**Condensed Technical Report Conclusions
for the Review of the
Joint Base Pearl Harbor-Hickam (JBPHH)
Interagency Team's Technical Memorandum on the
Lines of Evidence Evaluation of TPH Detections
Observed During Long-Term Monitoring**

Prepared for the Honolulu Board of Water Supply (BWS)

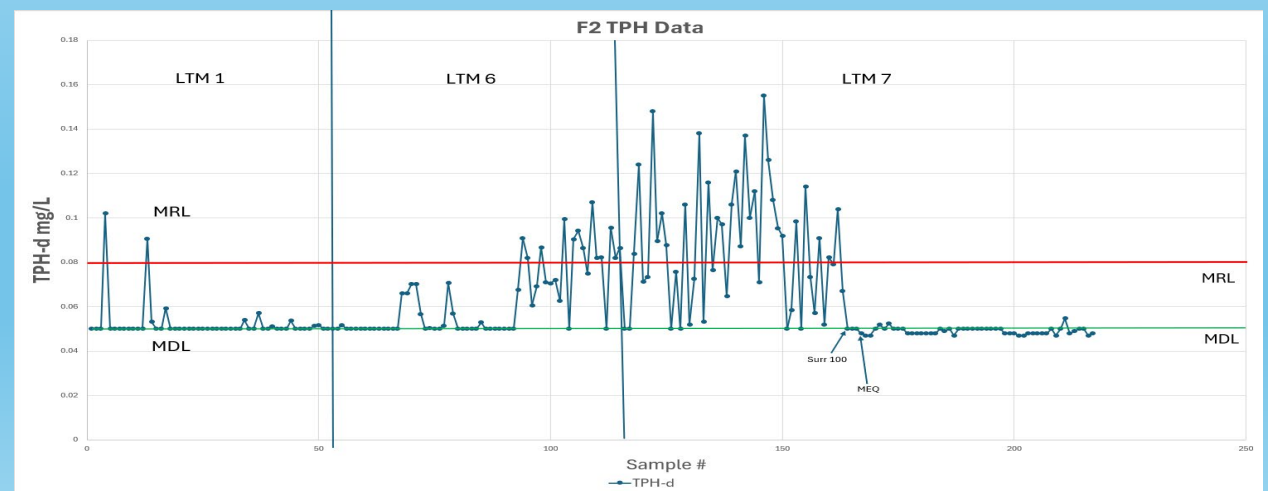
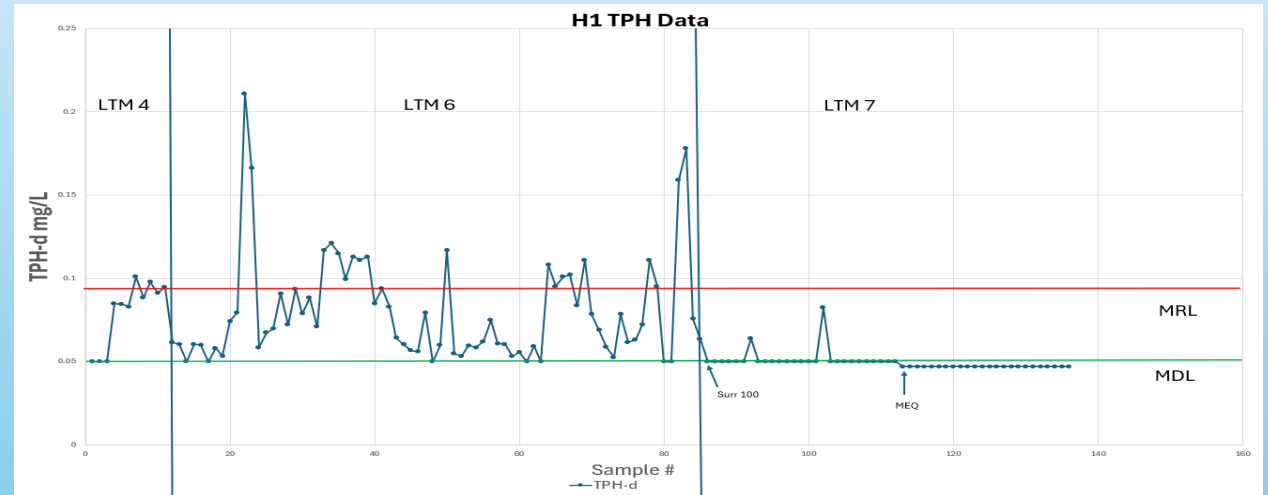
2. The authors claimed that the increased frequency of TPH detects had the same pattern for all zones, indicating a lab problem.

- Zones H1 and F2 do not have the same pattern for detections of TPH.
- Note LTM 6

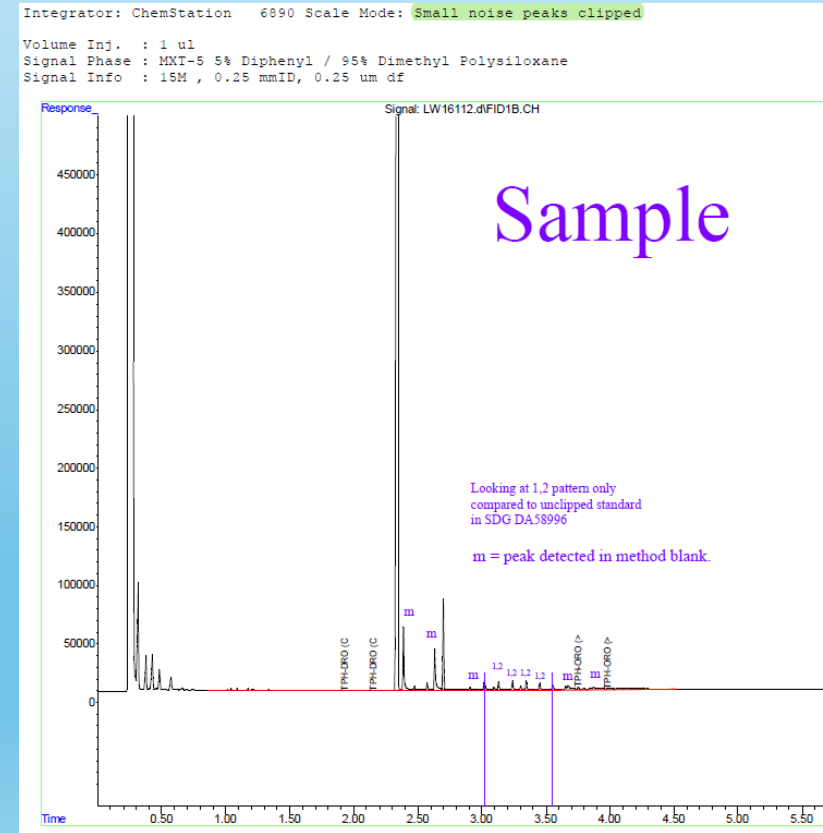
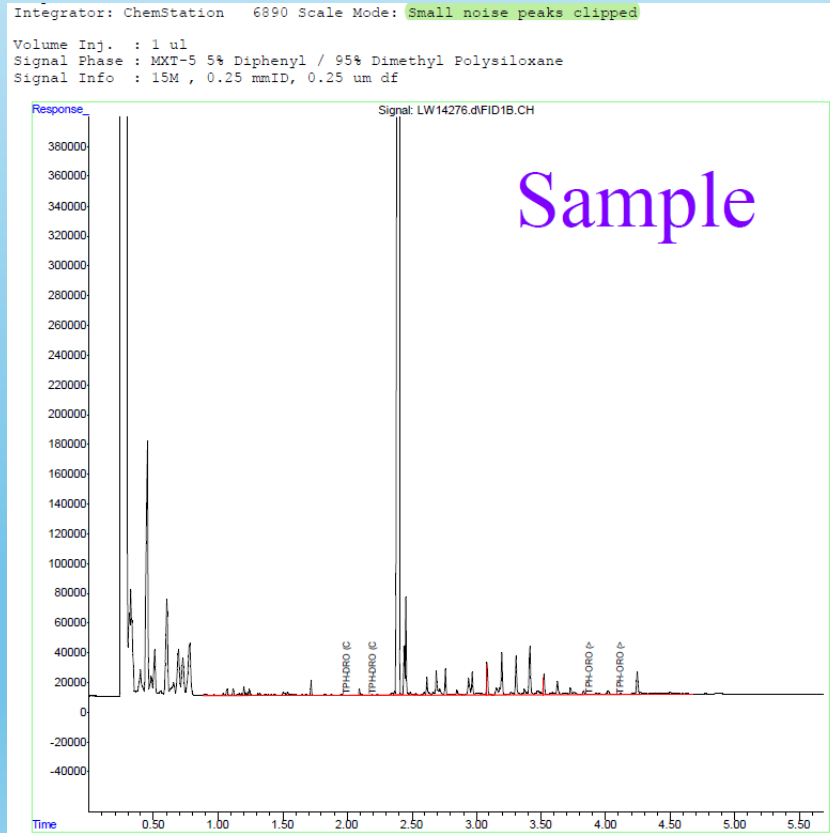
5. In many instances, there were a lot of extraneous peaks interfering with the ability to see low-level peaks of interest.

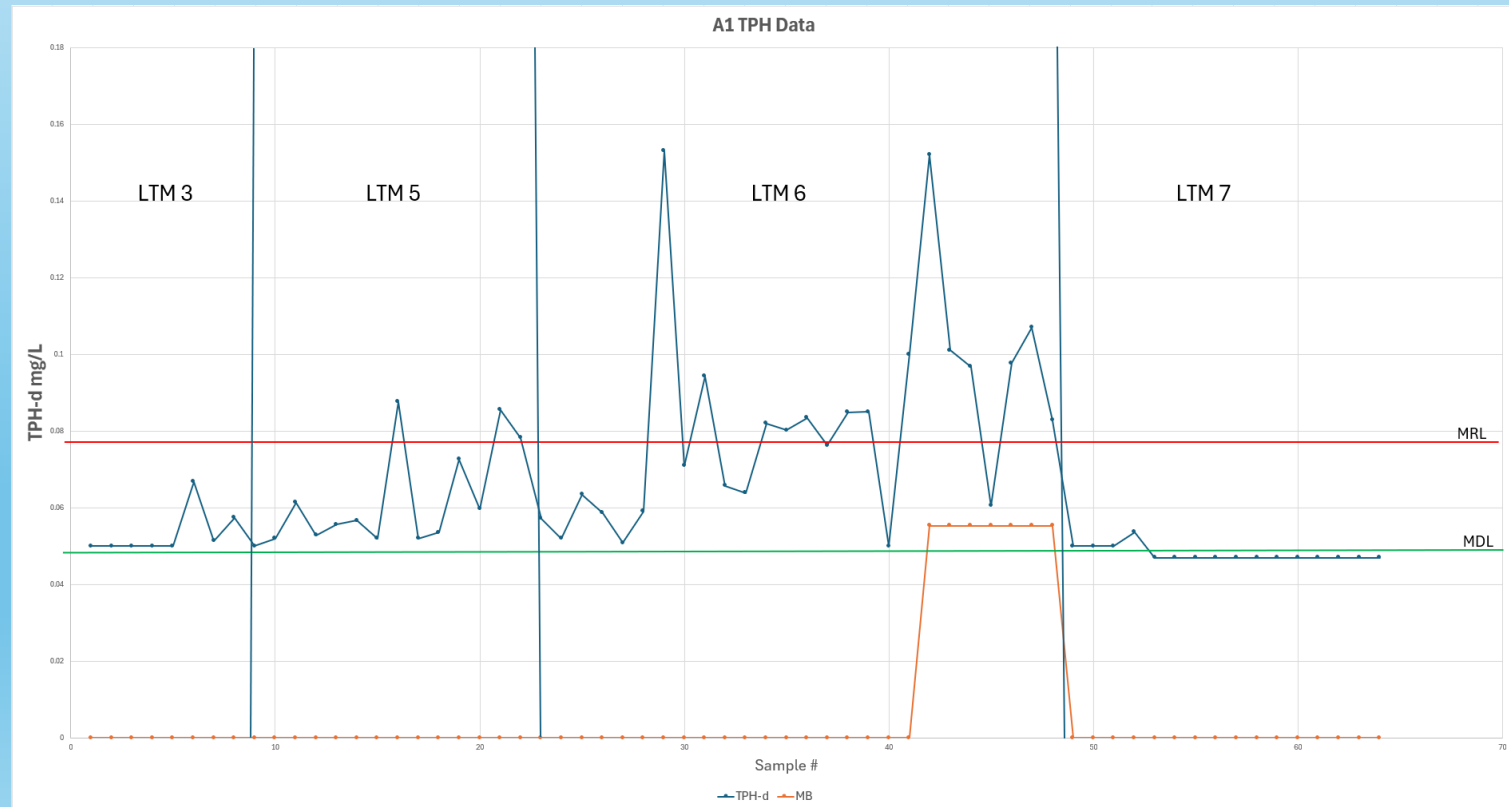
9. The method blanks show that laboratory contamination does not appear to be a major cause for the increased frequency of TPH detections.

- 66 Samples analyzed in Zone A1
- One contaminated blank – affects 6 samples
